[Docket No. FAA-2013-0724; Directorate Identifier 99-CE-013-AD; Amendment 39-17691; AD 99-26-19 R1]

Airworthiness Directives; Piper Aircraft, Inc. Airplanes

ACTION: Final rule.

99-26-19 R1 Piper Aircraft, Inc.: Amendment 39-17691; Docket No. FAA-2013-0724; Directorate Identifier 99-CE-013-AD.

Figure 1

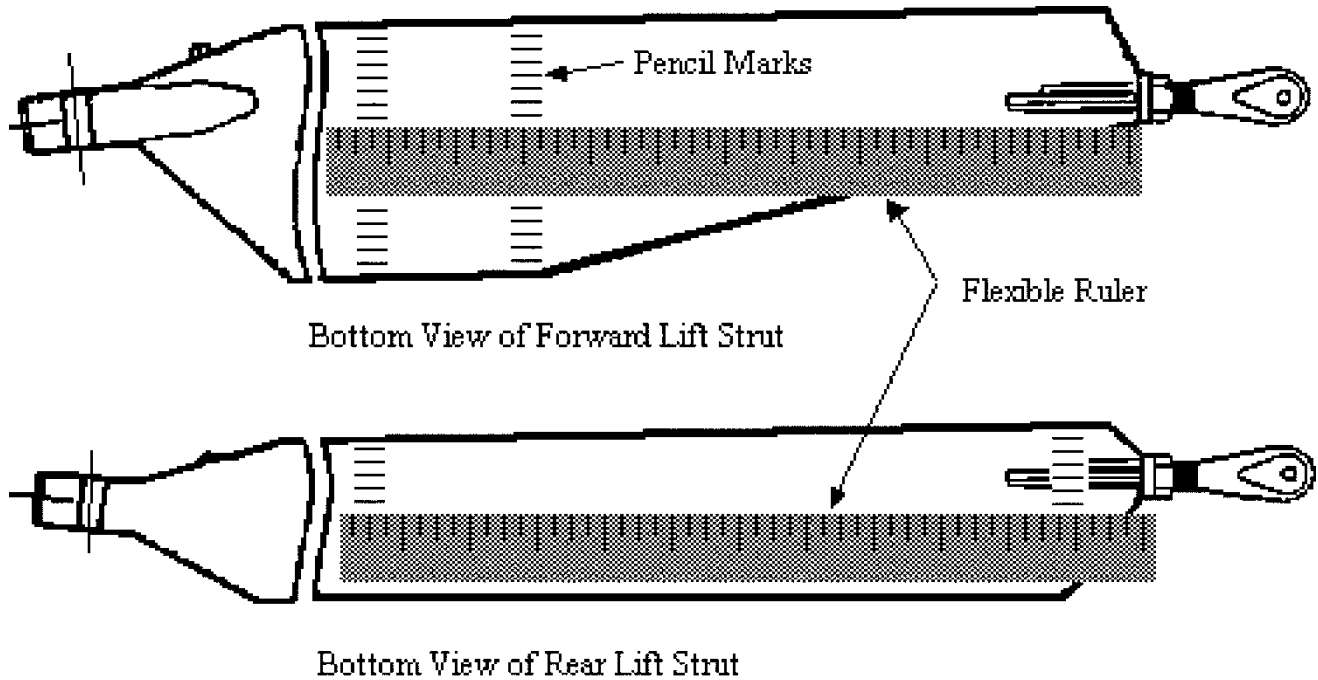
2. Using a flexible ruler, draw a 1/4-inch grid on the surface of the first 11 inches from the lower end of the strut as shown in Piper SB No. 528D, dated October 19, 1990, or Piper SB No. 910A, dated October 10, 1989. This can be done using a soft (2) pencil and should be done on both faces of the strut. As an alternative to drawing a complete grid, make two rows of marks spaced every 1/4-inch across the width of the strut. One row of marks should be about 11 inches from the lower end of the strut, and the second row should be several inches away where the strut starts to narrow. Lay the flexible ruler between respective tick marks of the two rows and use tape or a rubber band to keep the ruler in place. See Figure 1.
